Comment to the Independent Planning Commission on

Ulan Coal Mines Limited proposed Modification 4

by Geoff Mitchell 23rd June, 2019 on behalf of Geoff and Mary Mitchell, owners of the property . This comment will add some detail to the issues discussed on site at Woodbury on the 19th June, 2019 with Commissioners Gorden Kirkby and Brett Whelan and Planning Officer Jorge Van Den Brande and myself. The discussion was carried out at the Mona Creek Site 27 next to UCML's infrastructure pad in the shadows of the Mona Creek Cliff line. Commissioner Professor Chris Fell inspected other areas of Woodbury relating to MOD 4.

Photo 3. The leaning black pine tree can be seen at the top of the photo just left of middle.

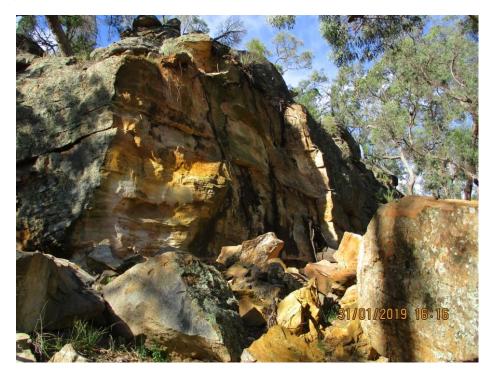
On Monday 17th June, 2019, I had a walk over the site above the rock fall. Walking along near the edge of the cliff I came across a 7 metre black pine tree leaning over. To see how stable it was I poked it with a small stick wherein it disappeared over the edge taking dirt and rocks with it. The tree movement and impact below were quite evident at the top of the cliff. Mary is considering nominating me for a Darwin Award. Ken did mention to me on the 3rd December inspection that a full geotechnical survey of the whole cliff line would take a couple of weeks. The IPC party did observe this tree [Photo 6] and what appear to be precarious rocks around this site.

There obviously has been other substantial movements at this rock fall since 2014. Comparing Photo 3 with Photo 4 below you will see that the large tree at the top right hand edge of the rock fall in Photo 4 has fallen over the cliff (see Photos 5 & 6), sometime between 18.03.2014 and 31.01.2019.

Photo 7. Boundary fence on left. Mona Creek Site 27 in middle, rock fall on right.

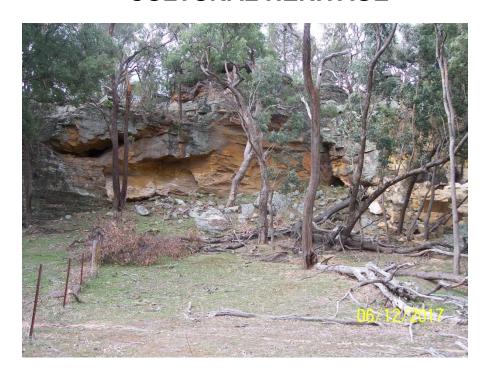
Peter Kuskie from SEA met on site with UCML's Brad Tanswell and myself on Tuesday 15th January, 2019 . From about 30 metres away from the rock fall Peter observed that the rock fall had not impacted on Mona Creek Site 27. Visually from that distance, see photo 7, I would agree with Peter as you get a decent perspective of the rock shelter in relation to the rock fall. Peter then proceeded to assess Mona Creek Sites 23~27. His report is on the IPC website ref:Annex E13. On his journey back to Mona Creek Site 27 Peter discovered a small quartz chip (22mm x13mm x 6mm) in a small shallow rock shelter away from the cliff line. This now becomes Mona Creek Site 372 and I presume logged in due course into the AHIMs data base.
